# MISSOURI 2019 AIRPORT LIGHTING PACKAGE

## WEST PACKAGE

## ADDENDUM NO. 1

November 2, 2020

16

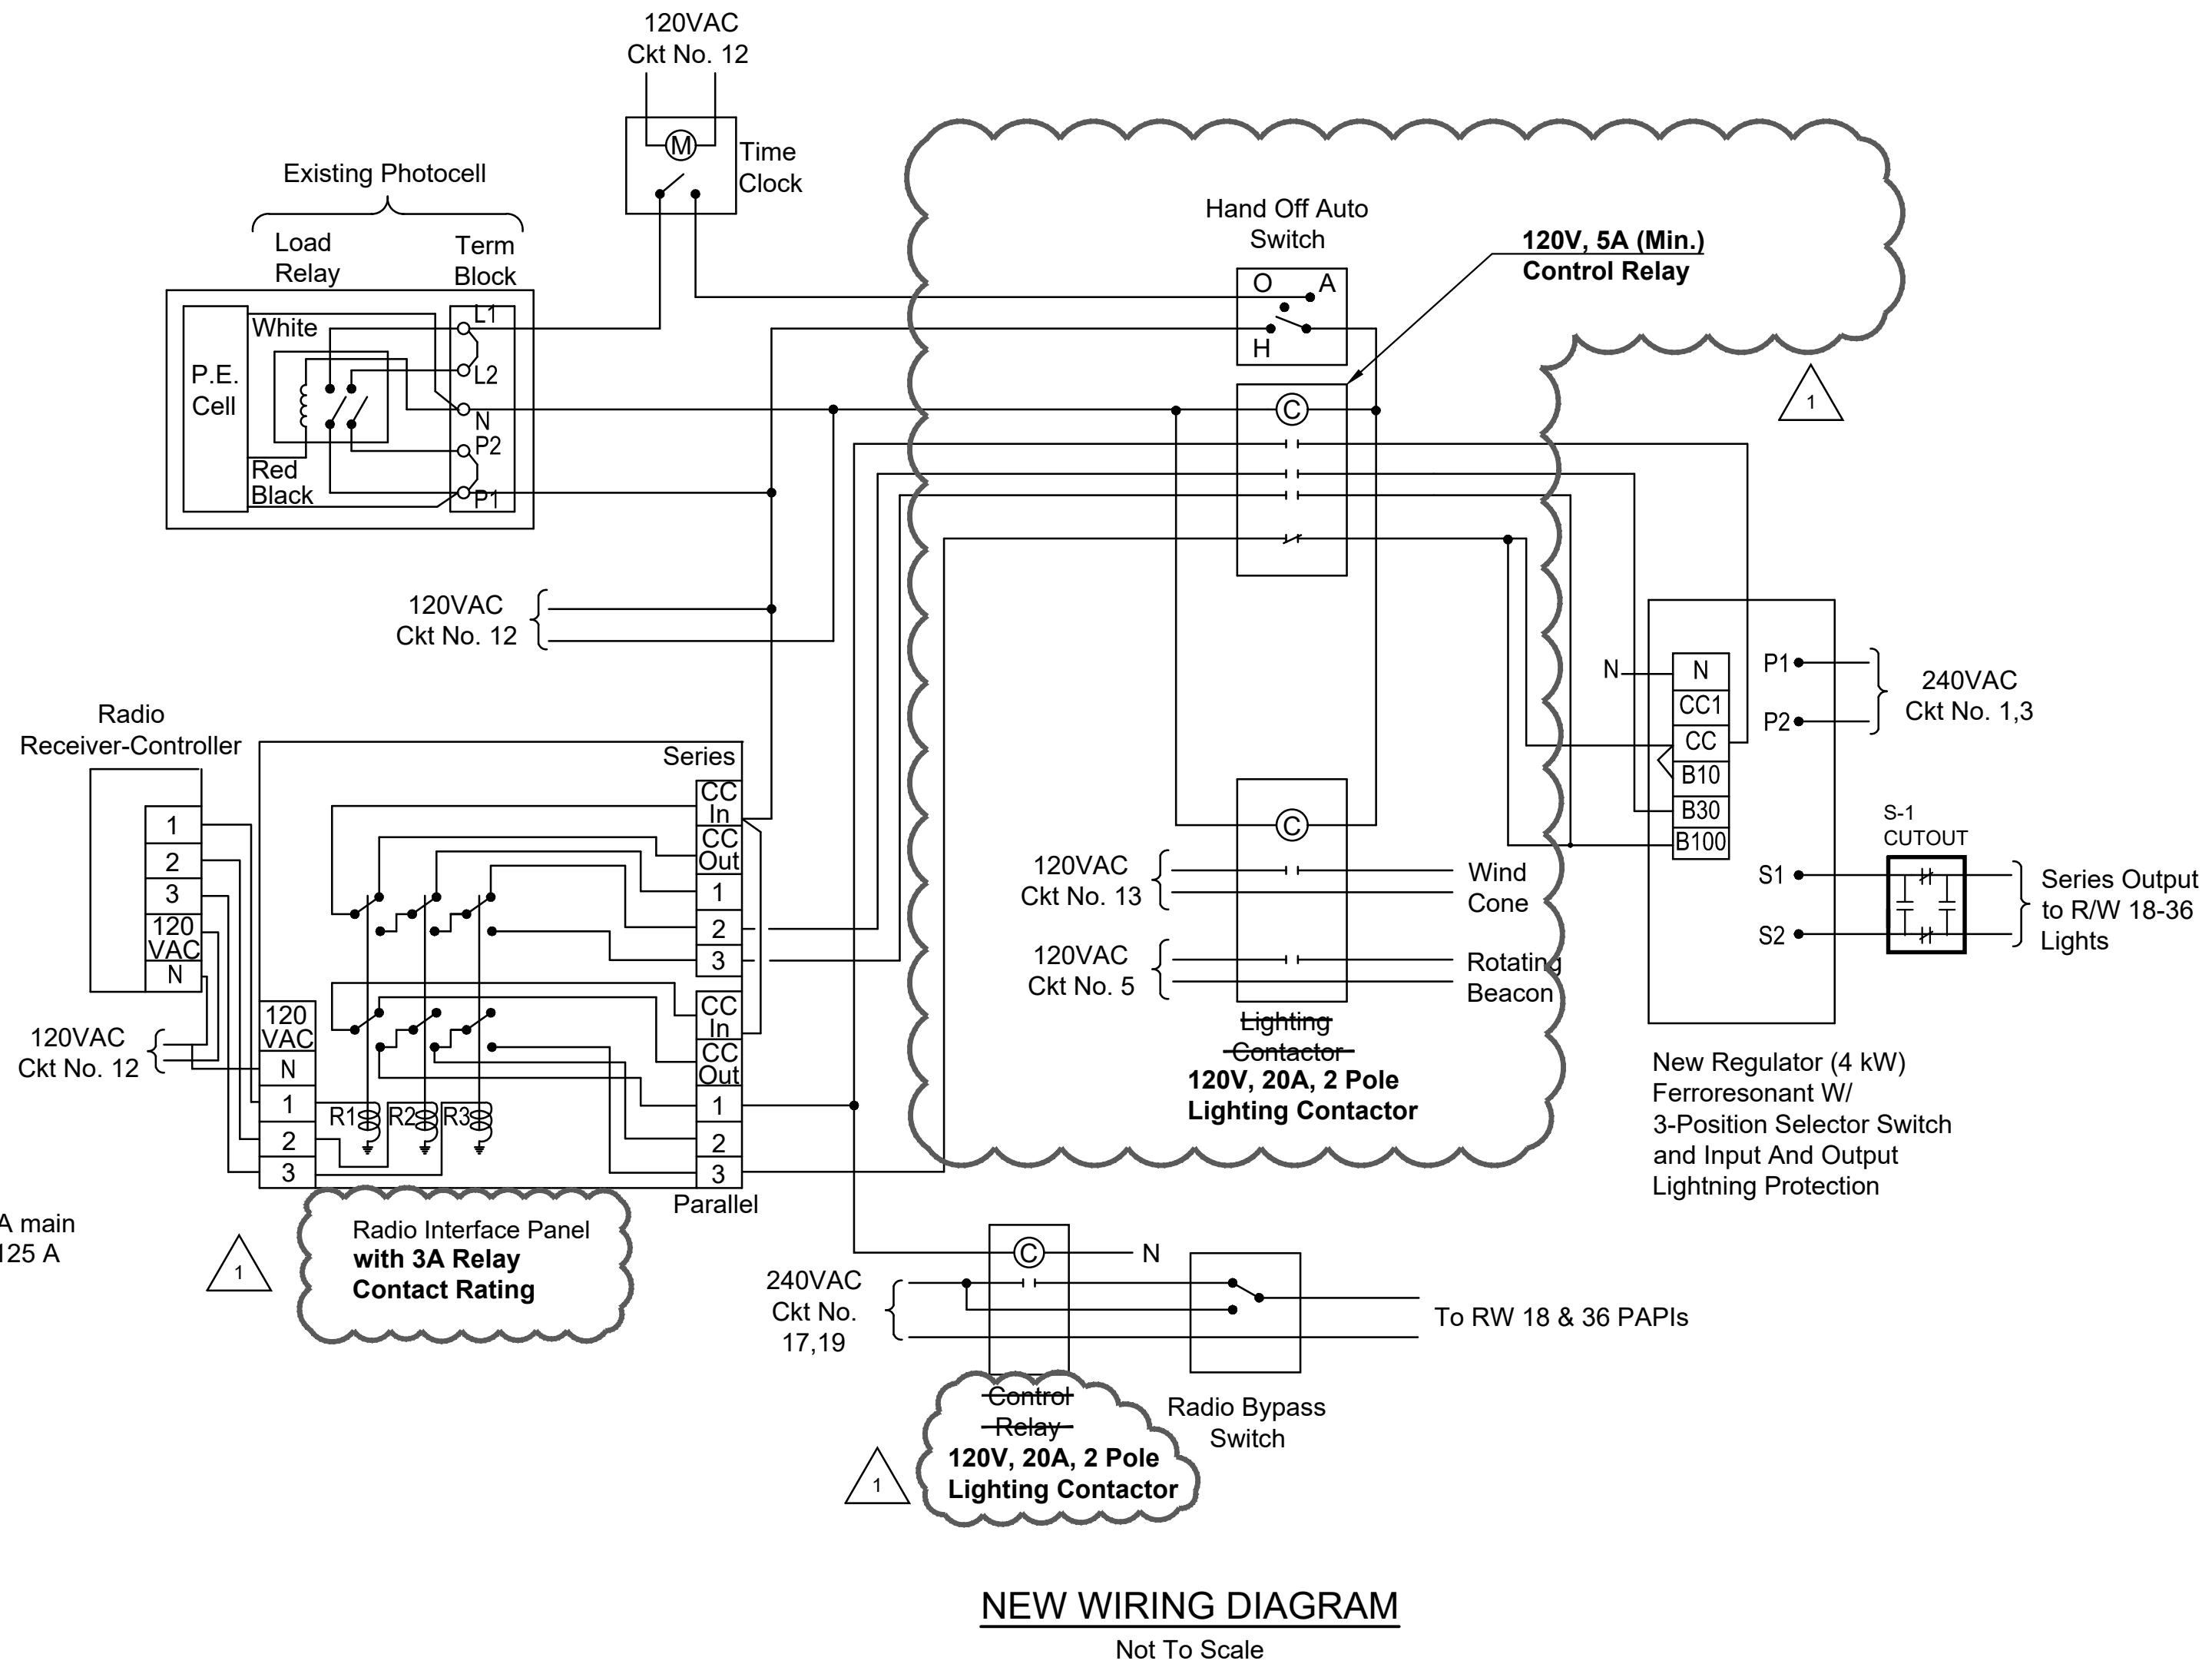
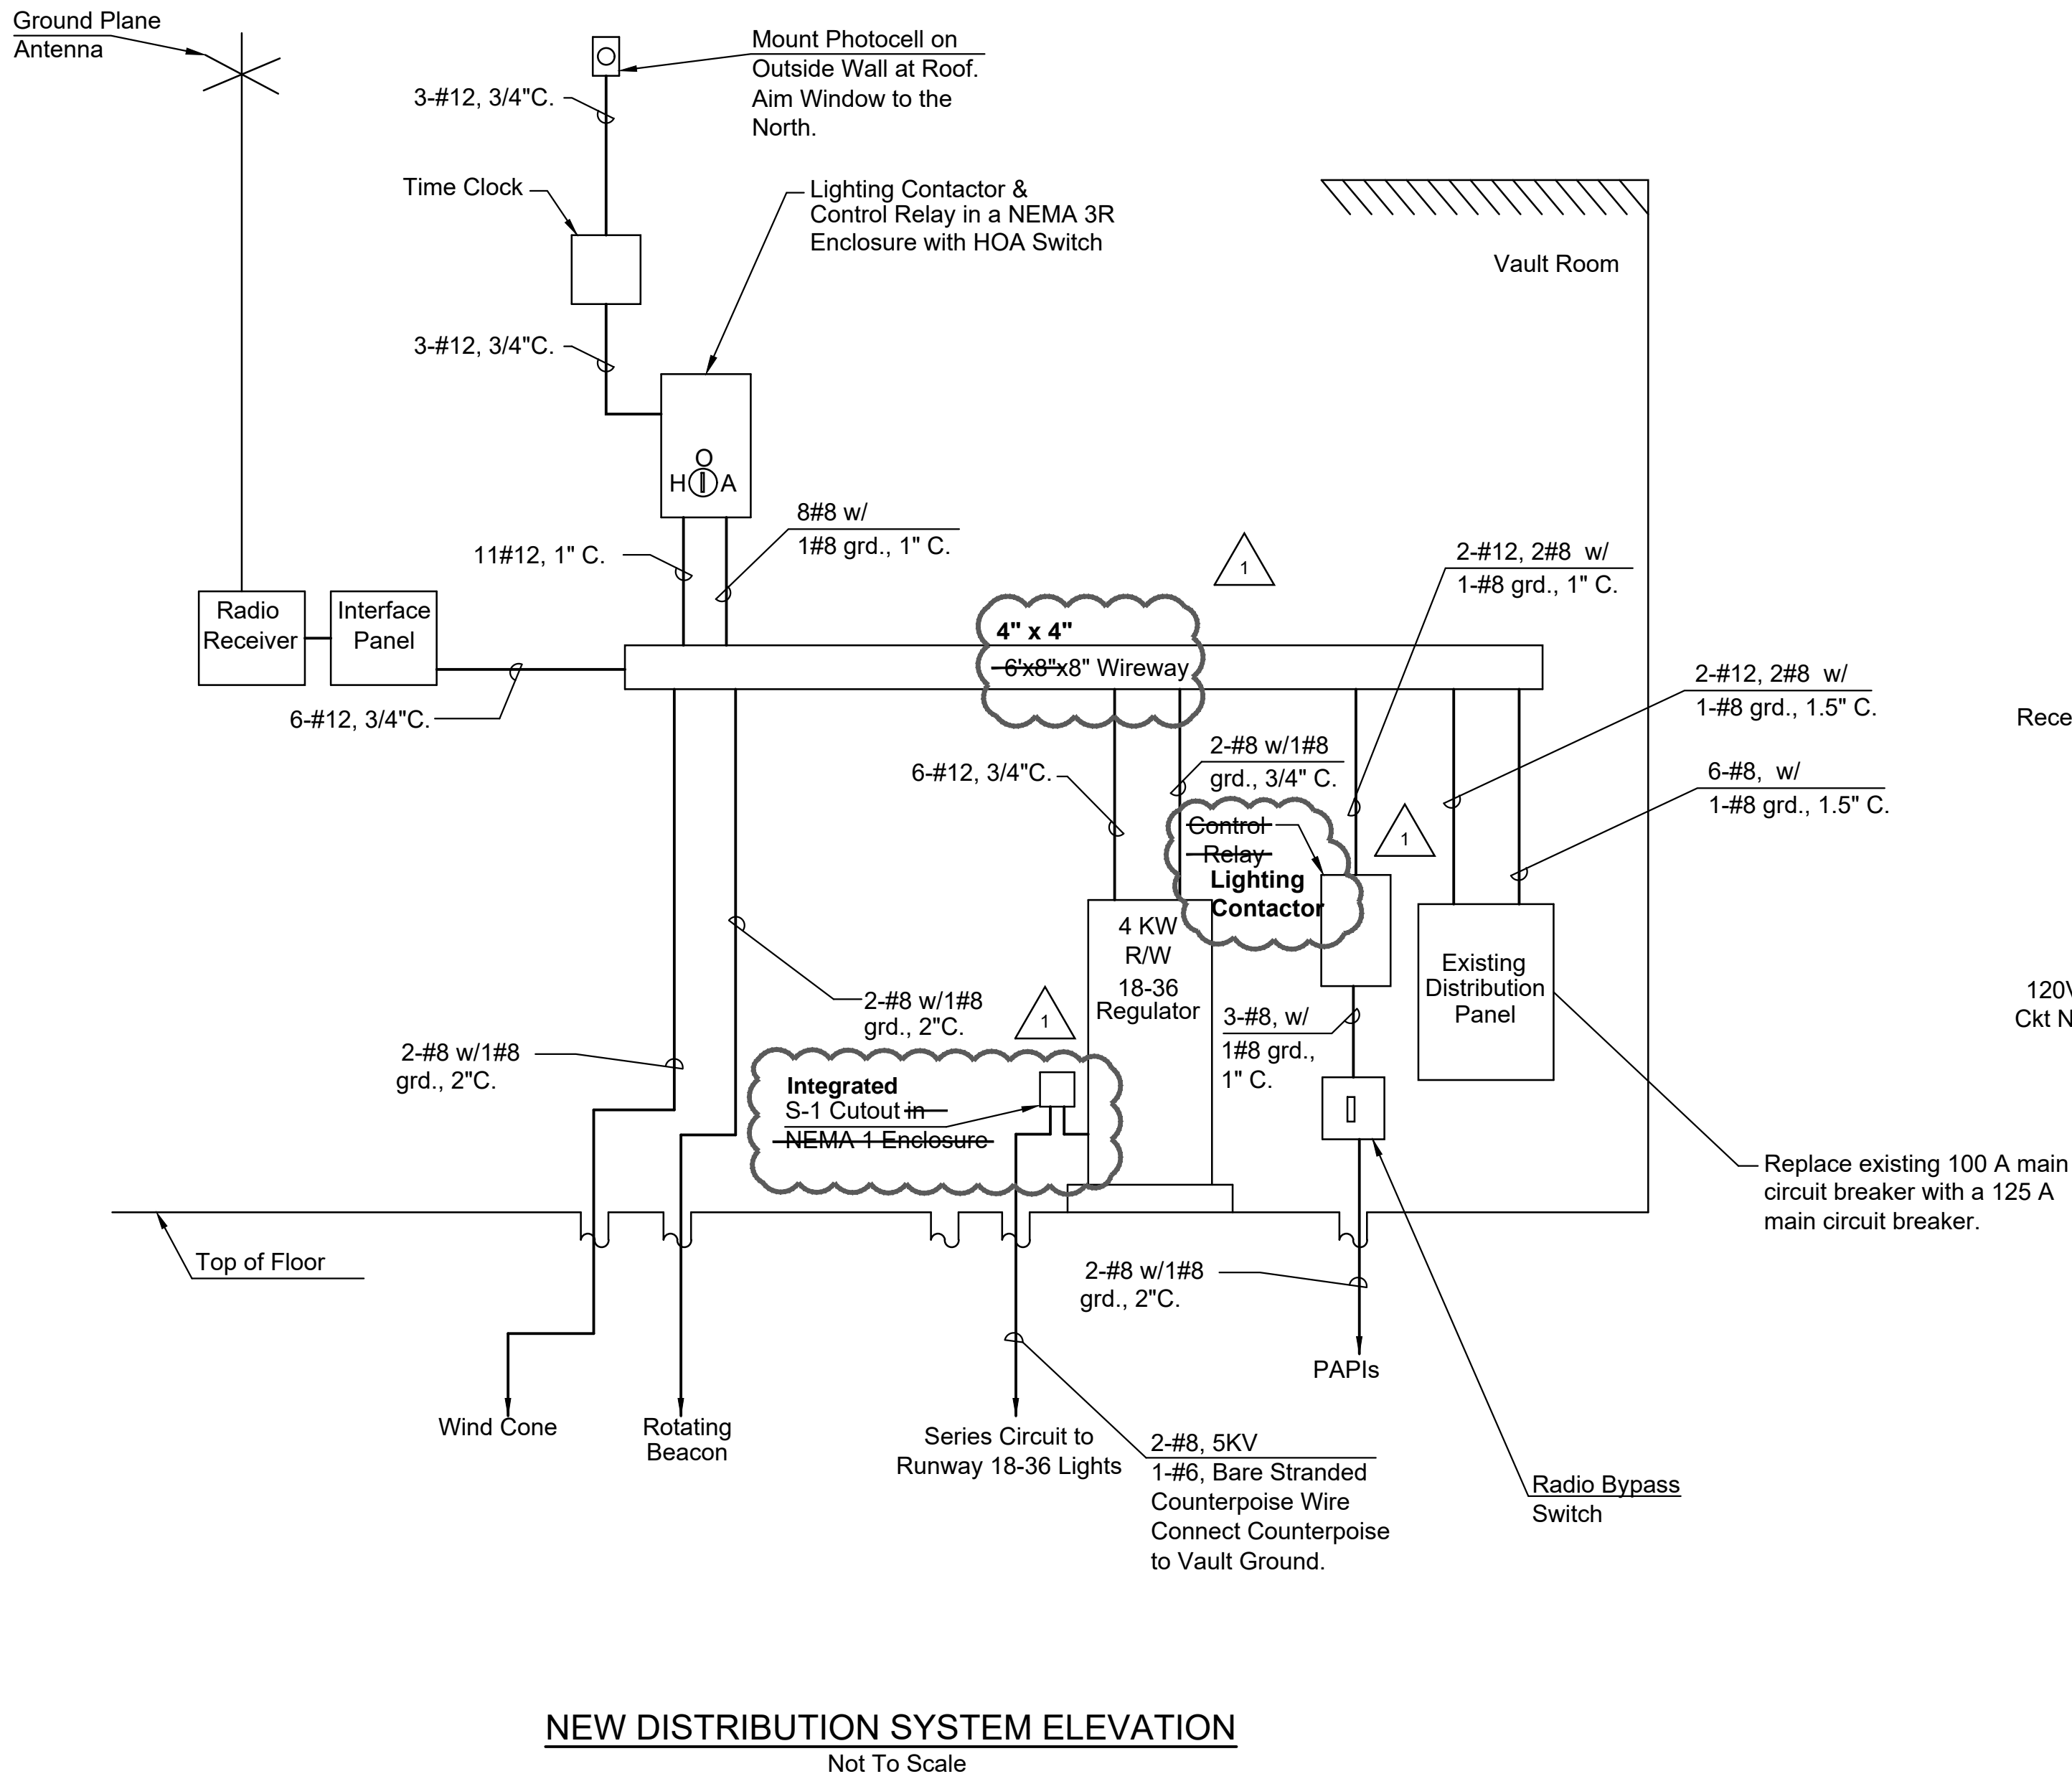
2. **Schedule A: Albany Municipal Airport**, Sheet No. 17 Distribution Schematic. The 8” x 8” wireway is now a 4” x 4” wireway. The 100A lighting contactor for the regulator, rotating beacon, and wind cone was removed. The regulator will now be controlled via a 120V, 5A (minimum) control relay and the rotating beacon and wind cone via a 20A, 2 pole lighting contactor. The PAPI control relay is now a 20A, 2 pole lighting contactor. Radio interface specifications were added to the label, and the callout for the S-1 cutout revised to indicate that this is to be integrated with the regulator. The Distribution System Elevation and Wiring Diagram Schematics were updated to reflect these changes.

DISTRIBUTION SCHEMATIC

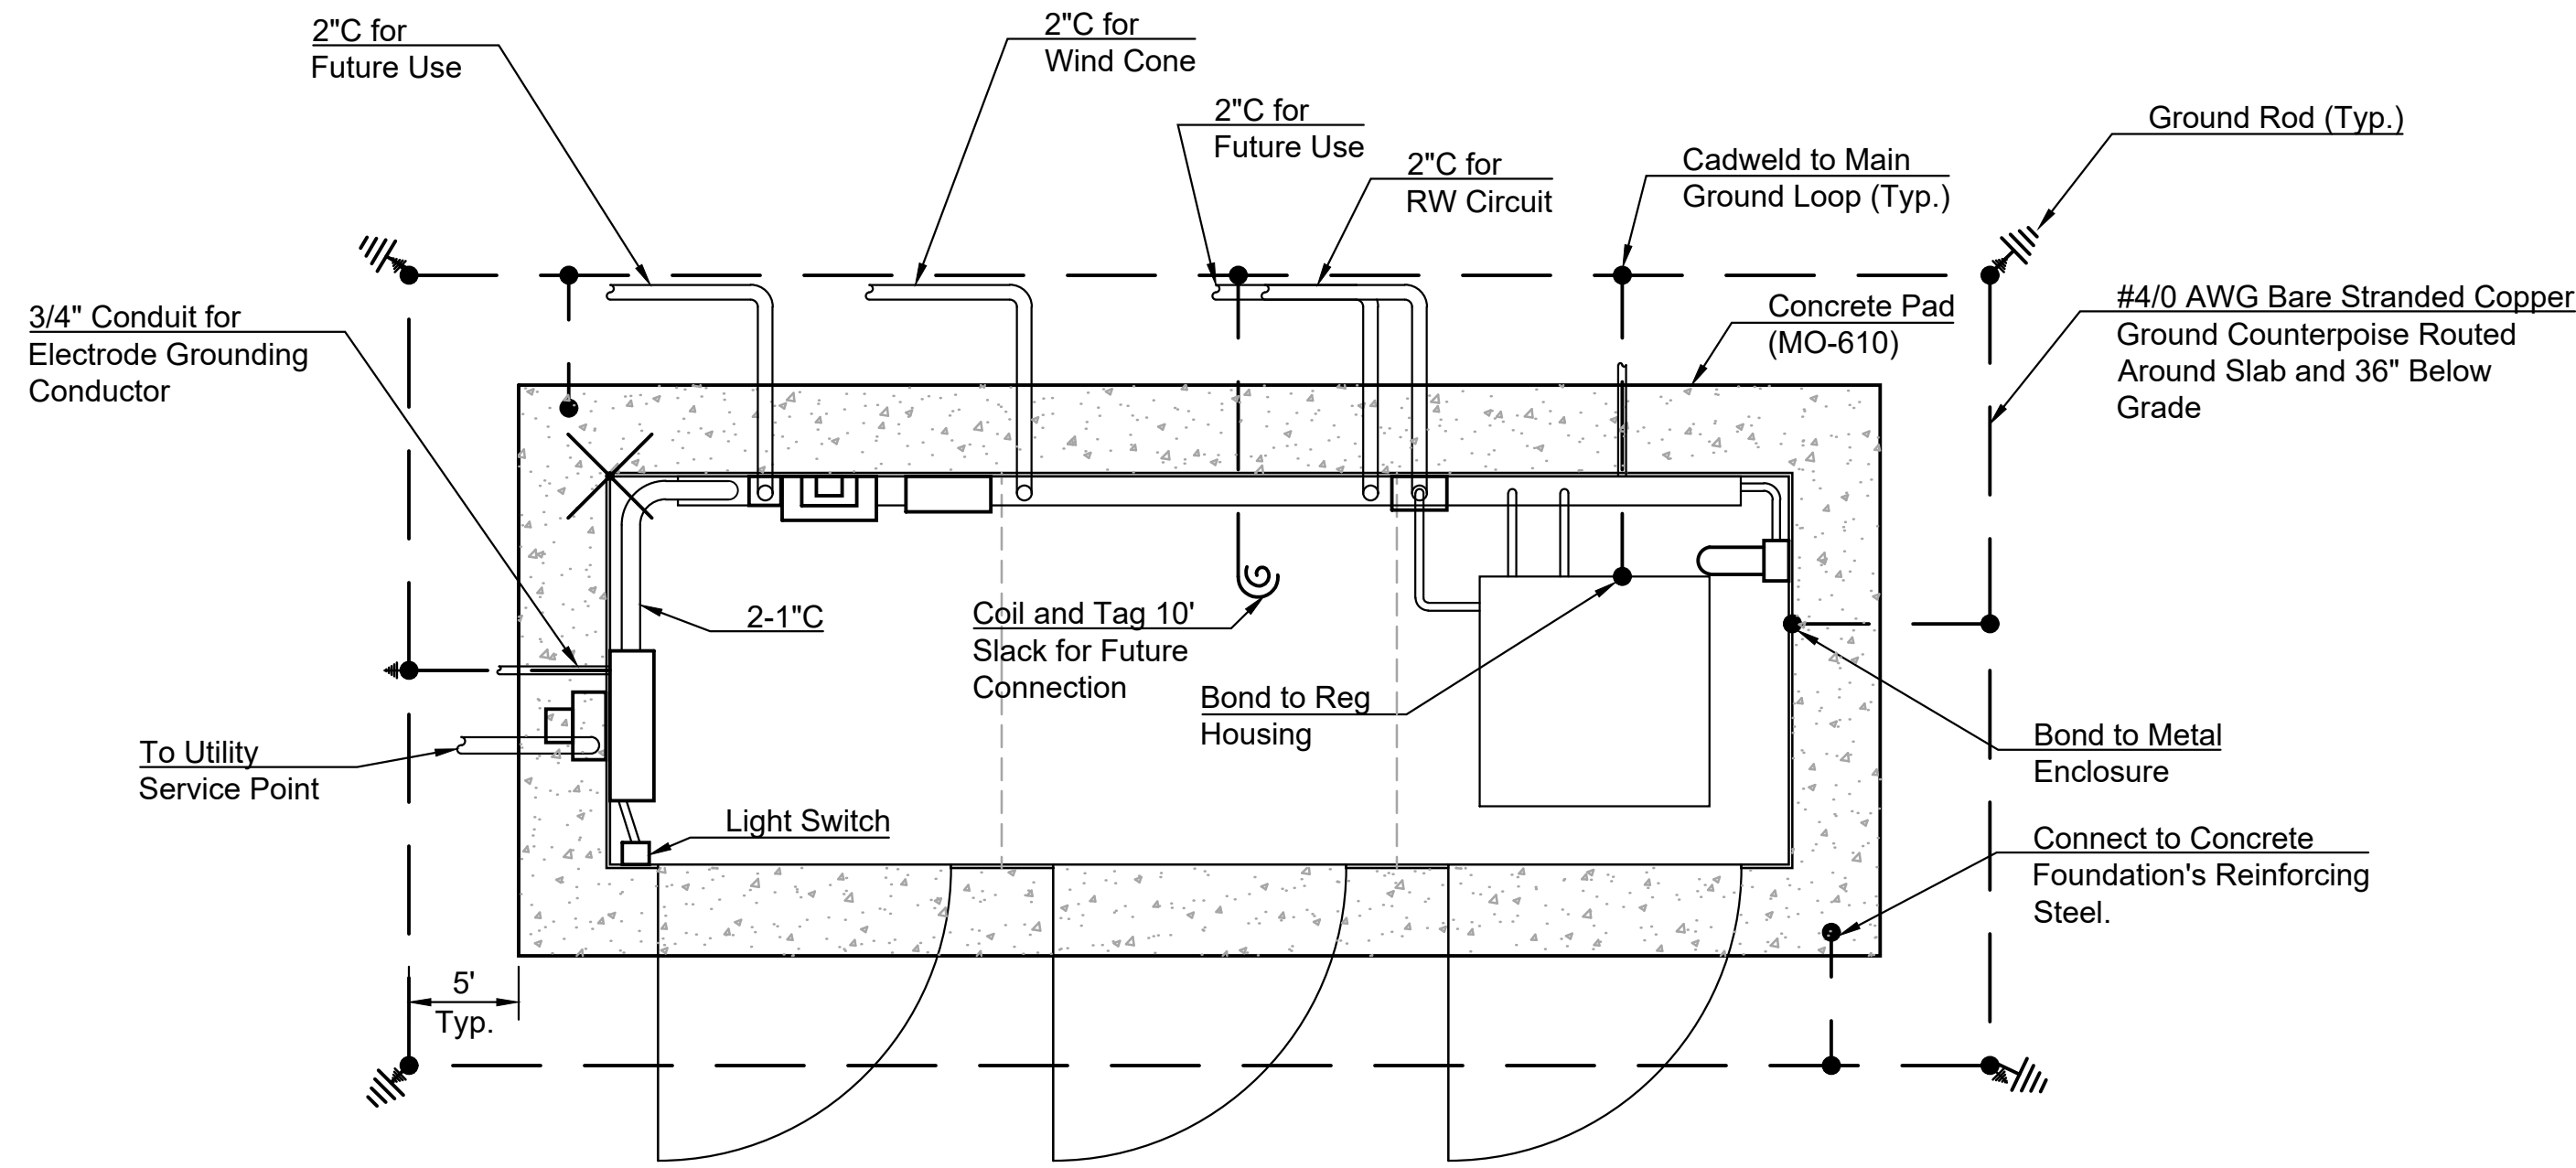
4. **Schedule B: Carrollton Memorial Airport**, Sheet No. 17 Distribution Schematic. The 6’x8” x 8” wireway is now a 4” x 4” wireway. The 100A lighting contactor for the regulator, rotating beacon, and wind cone was removed. The regulator will now be controlled via a 120V, 5A (minimum) control relay and the rotating beacon and wind cone via a 20A, 2 pole lighting contactor. The PAPI control relay is now a 20A, 2 pole lighting contactor. Radio interface specifications were added to the label, and the callout for the S-1 cutout revised to indicate that this is to be integrated with the regulator. The Distribution System Elevation and Wiring Diagram Schematics were updated to reflect these changes.
